PR/0832/22

Record of Executive Business and Chief Executive's Order

Reg. Reference: SDZ22A/0007 **Application Date:** 06-May-2022
Submission Type: New Application **Registration Date:** 06-May-2022

Proposed Development: Comprising Phase 1 of the Adamstown Boulevard Development Area and consists of 38,768.21sq.m. of residential development to be constructed in a mix of housing and apartment units, with 423 residential units proposed in total (of which 166 units are subject to the application for outline permission); The housing units for which permission is being sought are on a site of 9.22Ha shall comprise 75 two bedroom units, 113 three bedroom units and 69 four bedroom units, ranging from 2 to 3 storeys in height; Outline permission is sought on a site of 0.54Ha for the apartment block, which shall range from 5 to 9 storeys in height and comprises 11 studio units, 76 one bedroom units and 79 two bedroom units; All residential units are provided with private open space, in the form of private rear gardens or balconies; The proposed development includes approximately 0.95 Ha of public open space in the form of a linear open space located on the east of the site stretching betwe

Figure 2 no turning area at the end of Homezone

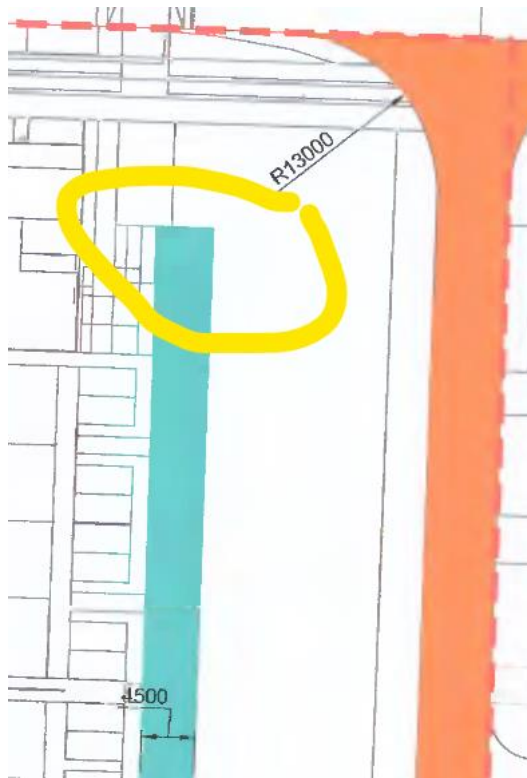
There are no turning locations at the end of homezones 3 and adjacent to the linear park, depending on the parking arrangements and the width of the road reversing could be difficult Figure 3.

1. The applicant is requested to provide:
 - a. A revised layout of not less than 1:200 showing a turning area at the end of Homezones adjacent to the linear park, or an autotrack showing vehicle manoeuvres to allow safe turning.

Figure 7 junction across the chevrons

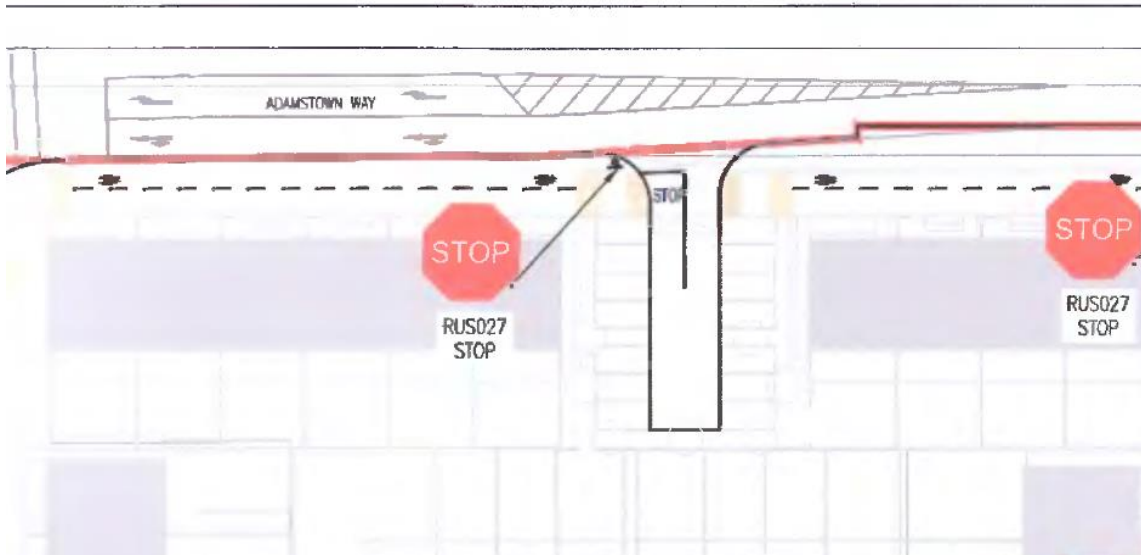
Figure 7 highlights a junction from the development close to another junction on Adamstown Way, the chevrons on Adamstown Way should be altered to allow right turning out of the proposed development.

- b. A revised layout of not less than 1:200 showing the road layout for the vehicle access at the northern end with Adamstown Way.
2. The Environmental Health Department request the application to submit a Traffic Noise Impact Assessment to include:
